Meeting: Traffic Management Meeting
Date: 20 June 2011
Subject: Various Schools in Sandy - Resolution of objections to the proposed 20mph Speed Limits and Zone
Report of: Basil Jackson, Assistant Director of Highways and Transportation.
Summary: To report to the Executive Member for Sustainable Communities Services the receipt of objections to proposals for 20mph speed limits and zones near schools in Sandy and seek approval for the implementation of this scheme.

Project Name
**Safer Routes to School
Sandy**

Drawing Title
**Transportation
Extent of 20mph Speed
Limit - Laburnum Lower &
Sandye Place Mid Sch.,**

Drawing No
400610-001-023

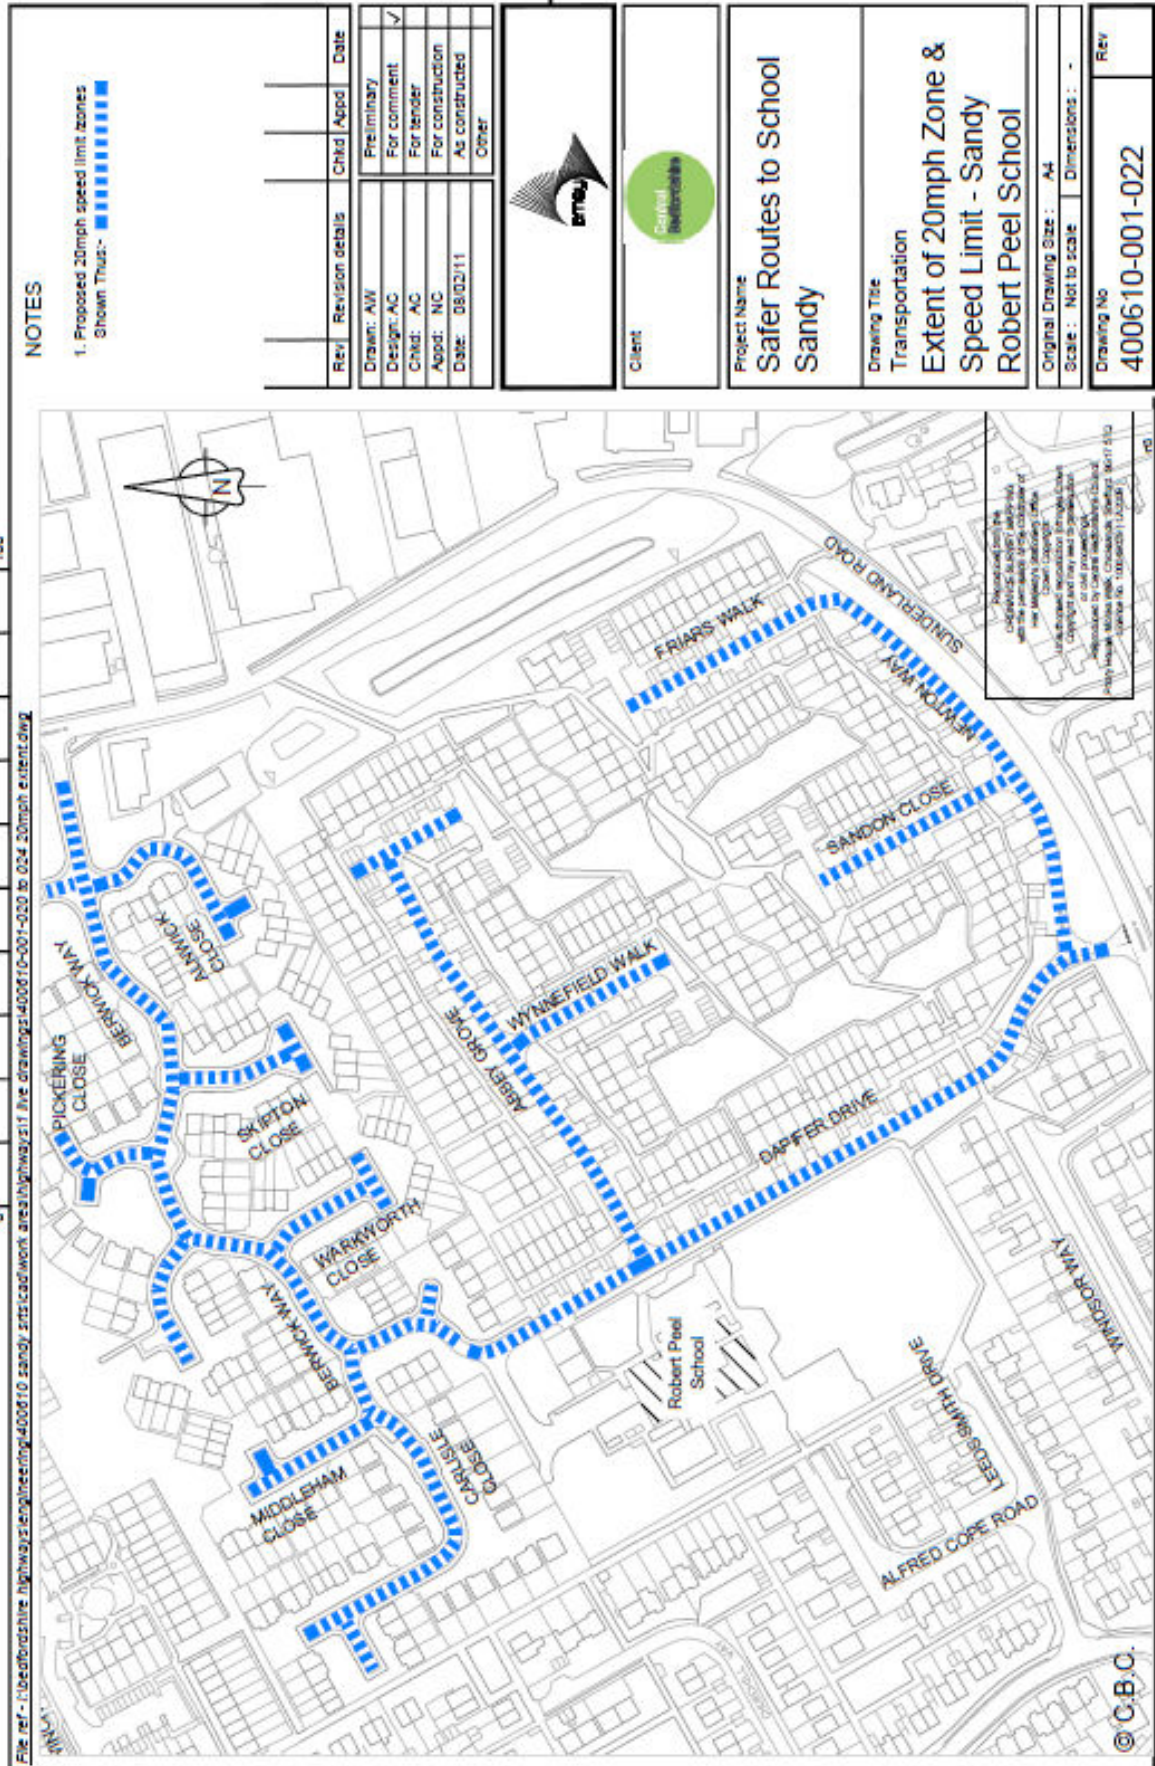
- a) There is an inconsistent and piecemeal application of speed limits in the town and this causes driver confusion. The entire built-up part of Sandy should have a 20mph speed limit.

- b) All of Swansholme Gardens should be covered by the 20mph limit.
 - c) School gate parking is a higher priority for attention near to Laburnum Lower School.

We would like to see the proposed 20 mph speed limit applied to the whole of Swansholme Gardens, Sandy, not just from 33/35 Swansholme Gardens to Kings Road, Sandy only. Several school children walk the entire length of Swansholme Gardens to get to school and there is a greater risk to children crossing this road along the straight part (between 1 - 33 Swansholme Gardens) where the speed of cars frequently reach 30 mph+.

However, we would like to see the extent of the proposed 20mph zone in Swansholme Gardens increased to the whole length of the road. We cannot see any sensible reason for ending the 20mph zone between nos 33 and 35. We are concerned that in doing so will simply encourage people to accelerate beyond the 30mph limit on leaving the 20mph zone to the end of the road which is an otherwise quiet residential street. Locating the change from 20mph to 30mph at the junction between Swansholme Gardens and Mill Lane would prevent this from happening as vehicles would need to slow for the junction anyway.

Let me deal first with the Laburnham Lower and Sandye Place Middle School scheme and I refer to the Drawing No. 400610-001-023. The zone approaching Laburnham Road Lower School and incorporating Robert Hunt Gardens seems logical and sensible and I really have no other comment to make.

So far as the Sandye Place Middle School scheme is concerned however I do have one fundamental suggestion to make. Please note that there is only one access for vehicles onto and off the estate through which Mill Lane and Swansholme Gardens are really the main roads. **That is along Swan Lane at the junction with Bedford Road.** It is possible for motor cycles to enter and leave the estate via a gap in bollards in Mill Lane 100 yards south of it's junction with Bedford Road and also via Kings Road and finally from Beeston over the river Ivel Bridges at the south end of Mill Lane. My wife and I have lived at our present house for more than 30 years and during that time the number of vehicles using all the roads on the estate has steadily increased both because there are on average more cars per household but also because in recent years more and more parents drive their children to Sandye Place School using the school entrance in Swansholme Gardens just north of Foster Grove. This same pedestrian entrance is also used by those working in the Youth Service office located on the school campus while their cars are left parked on the road in the close vicinity often creating an obstruction close to the aforesaid junction.

I read with interest the proposed speed limit to swansholmegardens, but am concerned why it stops at no 33, if you look at the road map outside house numbers 19 to 27 inclusive the long sweeping bend has at times seen some near misses, as parents turn in the cull de sac opposite no 21 wear I live to drop off the little treasures and turn round at same time, this area is completely blind if coming from school area. May I ask why all the other proposals of speed limits are the full length of road but we only get half? I do hope this highlights an overlooked issue as one day damage or injury will happen, regards X X Xxxxx number xx swansholmegardens.

- a) The existing and proposed speed limits cover self-contained areas of Sandy, which generally falls in line with Government advice. There is a long-term trend towards imposing lower speed limits and it is possible that future consideration could be given to 20mph limits in other areas of Sandy. However, it is important that they are largely self-enforcing and this would not be the case in some of Sandy's roads. Hence, it is unlikely to be feasible to impose a blanket 20mph limit across the whole town.

- b) The speed limit proposals are centred on schools for obvious road safety reasons. In addition, they have been confined to relatively small zones where drivers will hopefully respect the need for a lower speed limit. If all of Swansholme Gardens was covered by a 20mph limit it would cover a significantly larger area and some roads would not be suitable due to existing traffic speeds, meaning that compliance with a 20mph limit would be poor.

- c) As part of the Sandy 'Safer Routes to Schools' project an assessment of parking outside all schools was carried out and restrictions are due to be implemented shortly. At Laburnum Lower School this involves legalising the School Keep Clear markings only.

Sandy Upper School

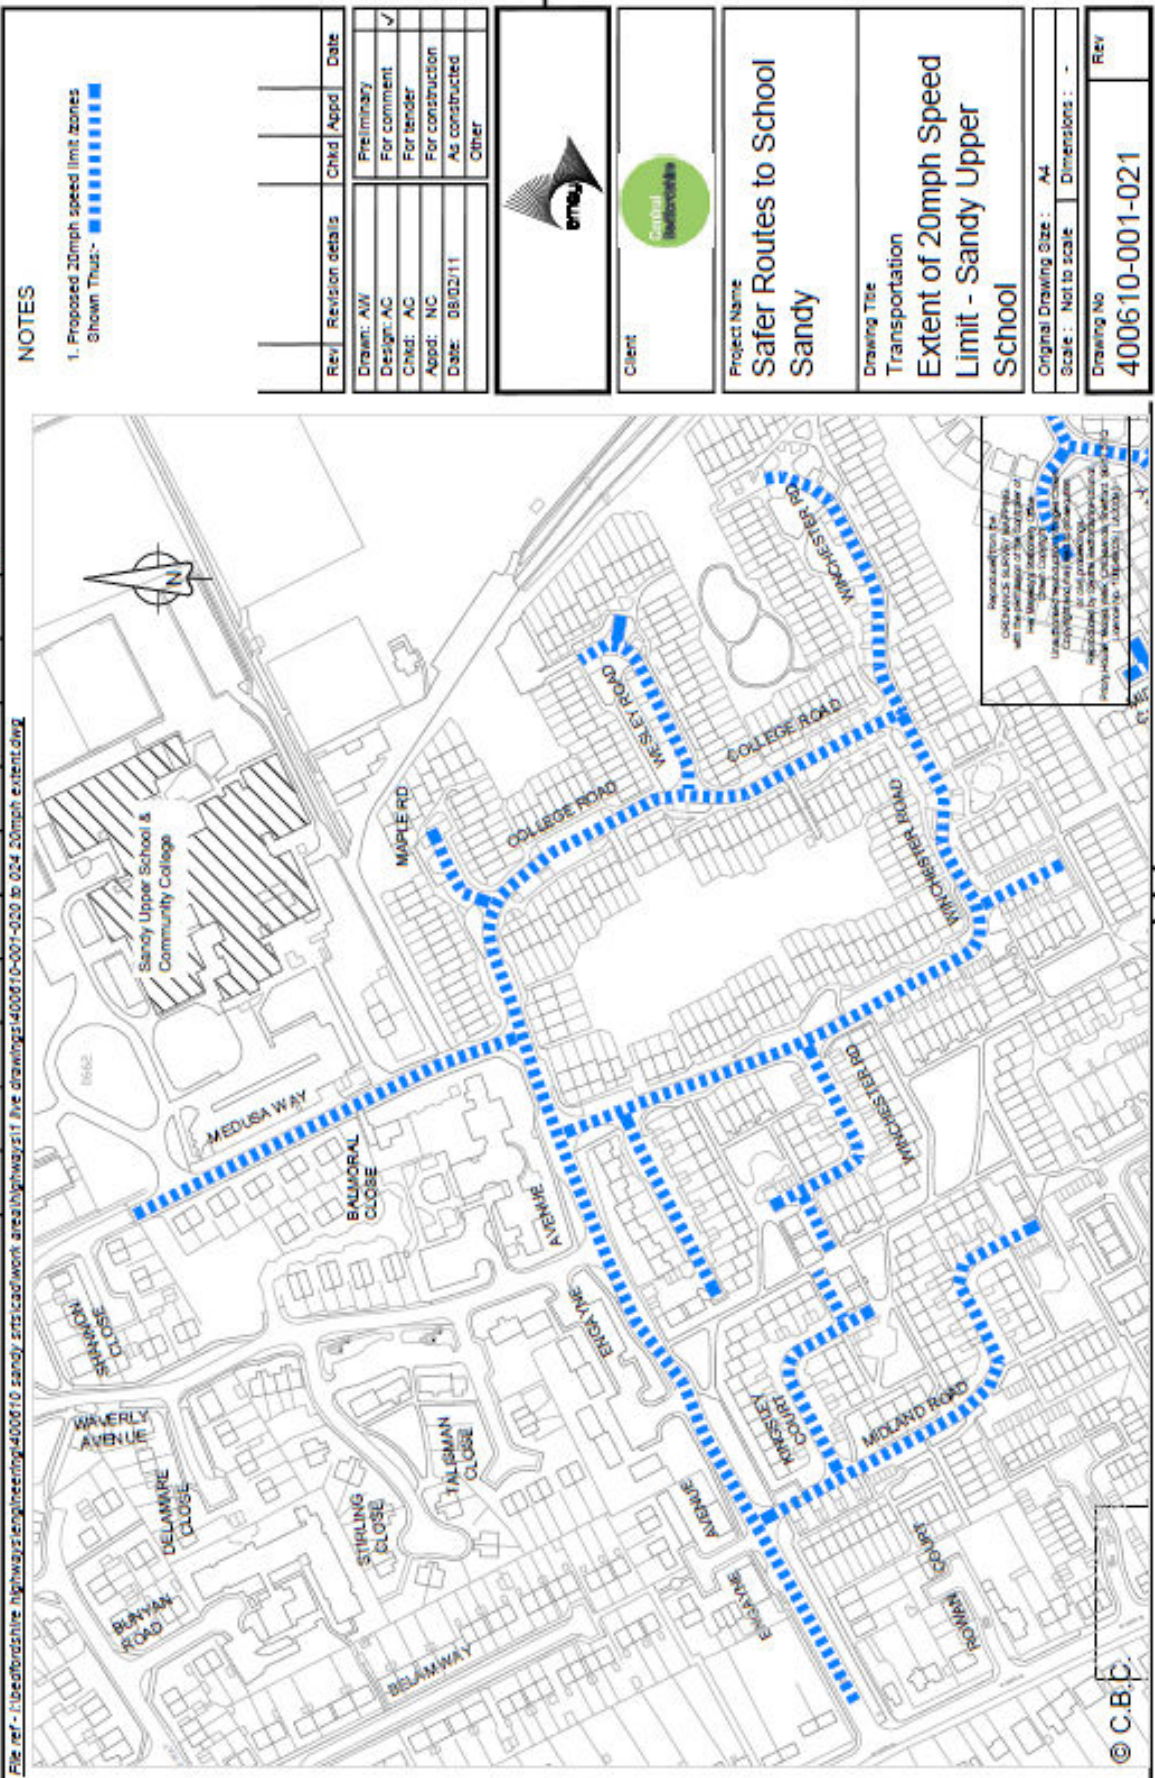
My objection to this order is that it does not include Waverley Avenue which as far as footfall goes is used by students of Sandy Upper, Sandy Middle, Robert Peel and Maple Tree, basically a continuation of Robin Close.

15. The following observations relate to the specific points that have been raised in respect to the proposals outside Sandy Upper School:-
 - a) If the Waverly Avenue area was also covered by a 20mph limit it would cover a significantly larger area and some roads would not be suitable due to the existing speed of traffic on them, meaning that compliance with a 20mph limit would be poor. The Winchester Road area has been included within the 20mph limit because the roads naturally lead to lower vehicle speeds and are more likely to be used as walking routes to the school.

St. Swithuns Lower School

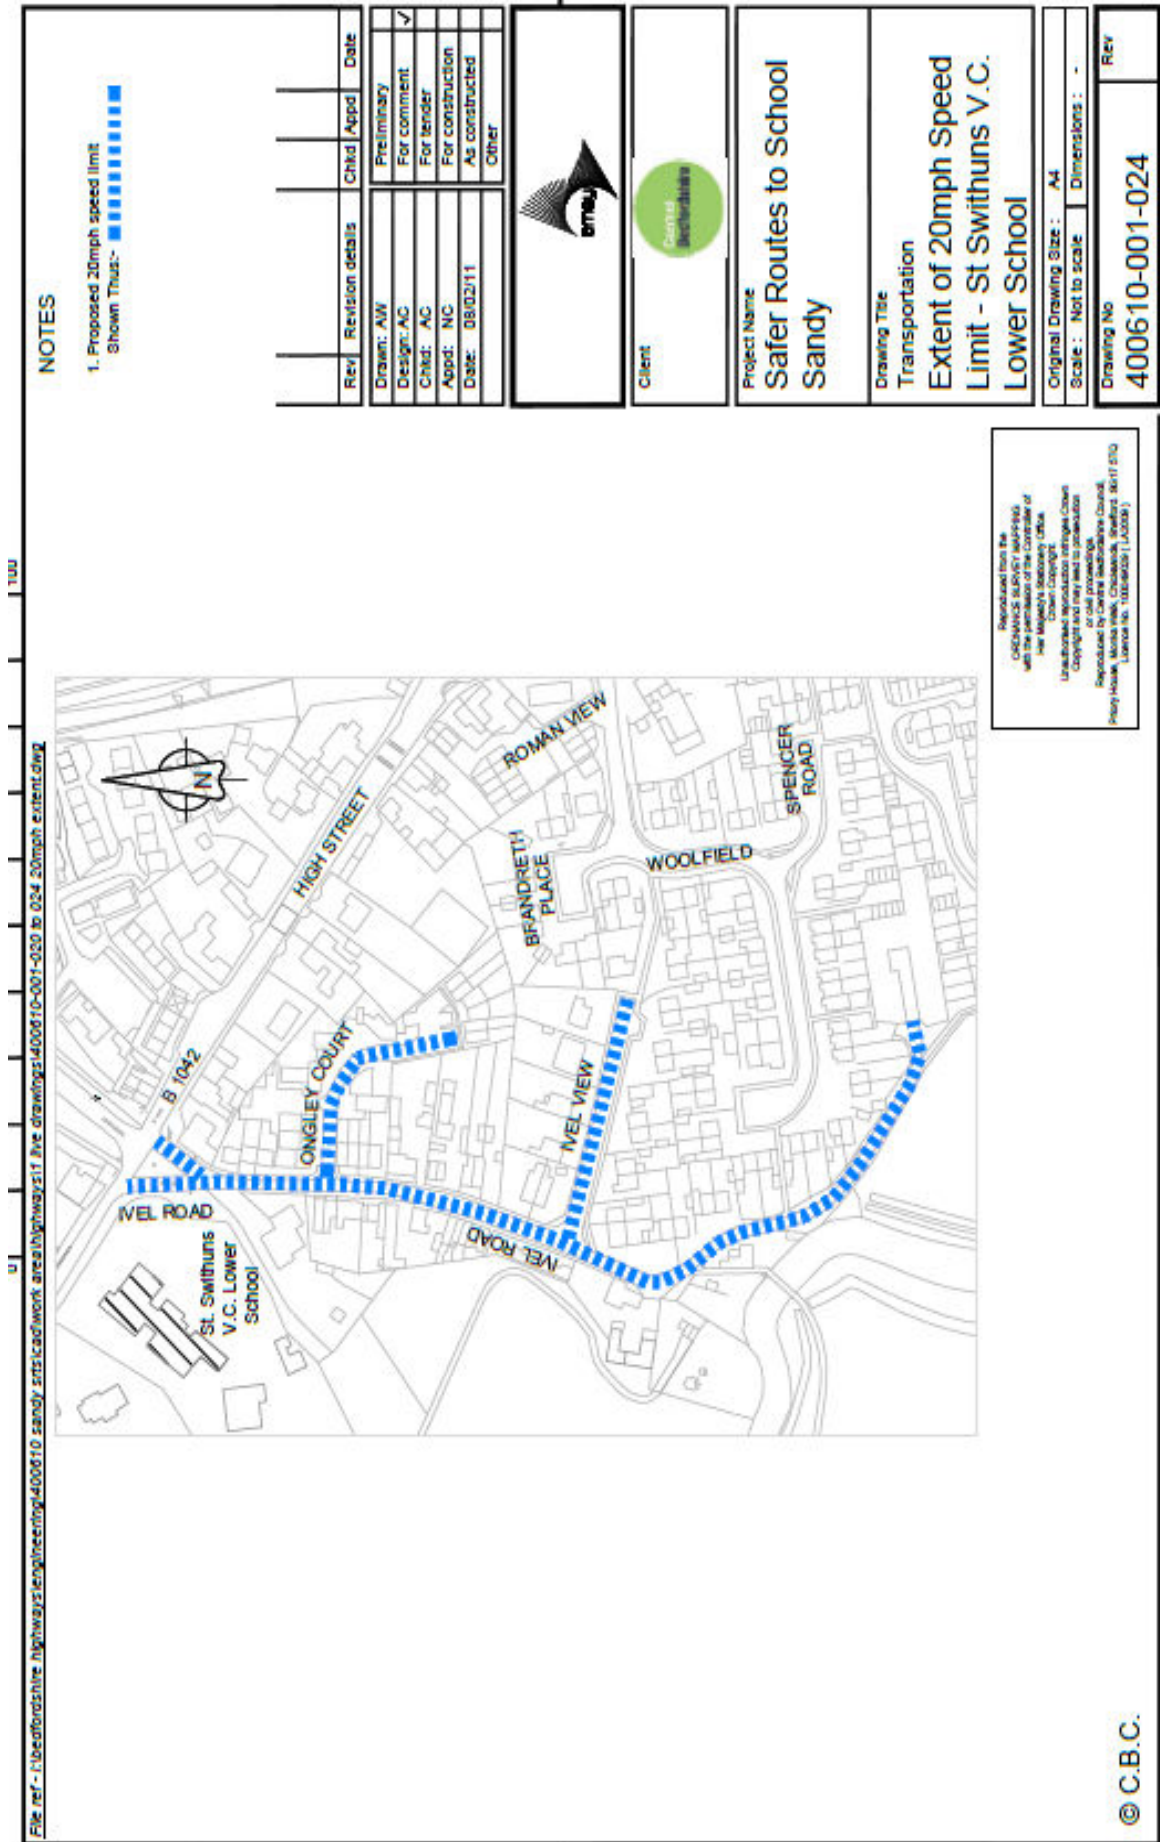
- 1 The road is so narrow no-one speeds anyway.
- 2 Parking is so bad. Cars are left all day while the occupants catch trains.,and parents taking and collecting children from school fill the road.
- 3 There is never anyone there to police the road. The High street is an example of this.
- 4 Cannot justify the cost.

A visit to the Ivel Road area of Sandy, particularly at school start and finish times, will see that it is physically impossible for any vehicle to exceed 20 mph!!

16. The following observations relate to the specific points that have been raised in respect to the proposals outside St Swithuns Lower School:-
 - a) It is acknowledged that this 20mph limit covers a small area where the character of the roads already results in low vehicle speeds. However, it is hoped that a 20mph limit will lower speeds further and will emphasise to drivers that they are entering an area where extra care is needed. In addition, it provides consistency of speed limits near to schools in Sandy.

Maple Tree Lower School

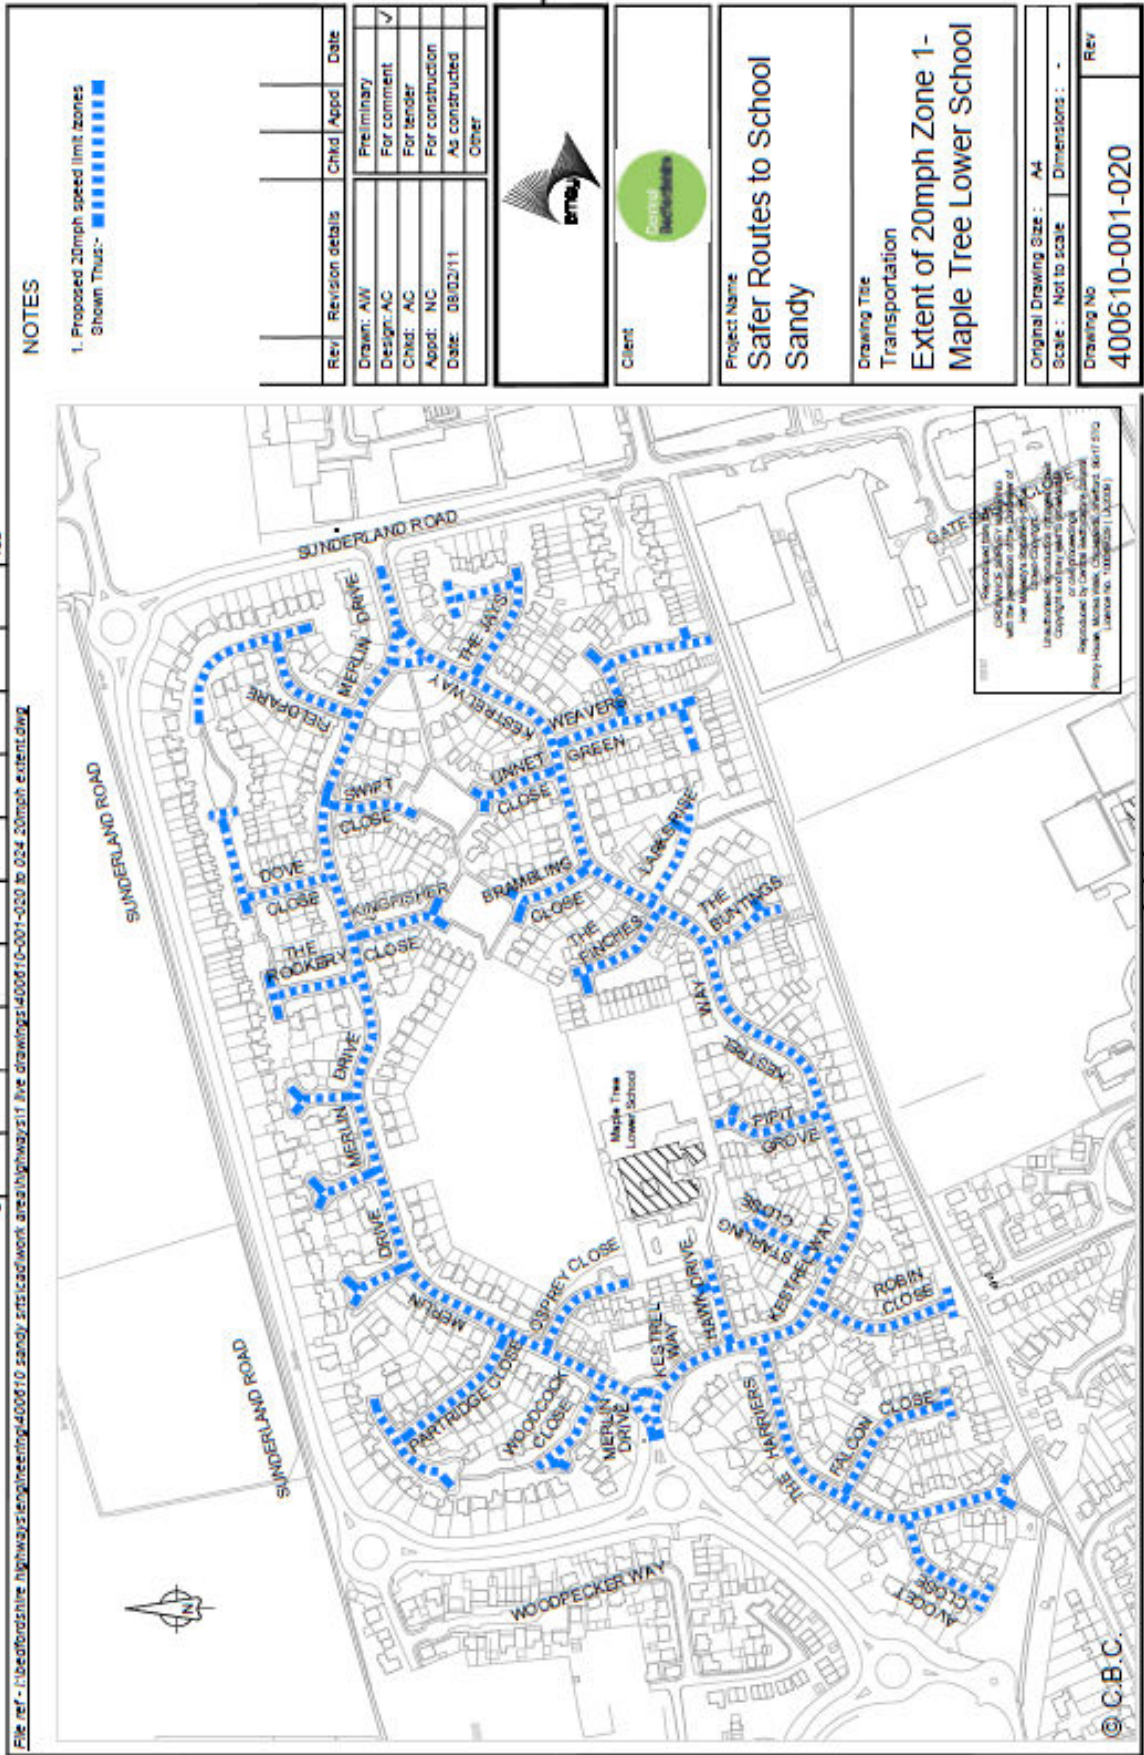
- a) The existing road humps already keep speeds low, so a 20mph speed limit is not needed.
 - b) Ivel Park and Goldfinch Drive should be included within the 20mph zone.

17. The following observations relate to the specific points that have been raised in respect to the proposals outside Maple Tree Lower School:-
 - a) The original design of the Fallowfield estate included road humps and other traffic calming features and it was always anticipated that a 20mph zone would be introduced. This was delayed for various reasons, but it has been decided that this should be included in the current proposal. Regulations dictate that 20mph zones must have traffic calming measures in place at specified intervals and this is the case in Fallowfield.

- b) Ivel Park and Goldfinch Drive are slightly remote from the proposed 20mph zone, so could not be included. In addition, the roads are not traffic-calmed and do not have a school.
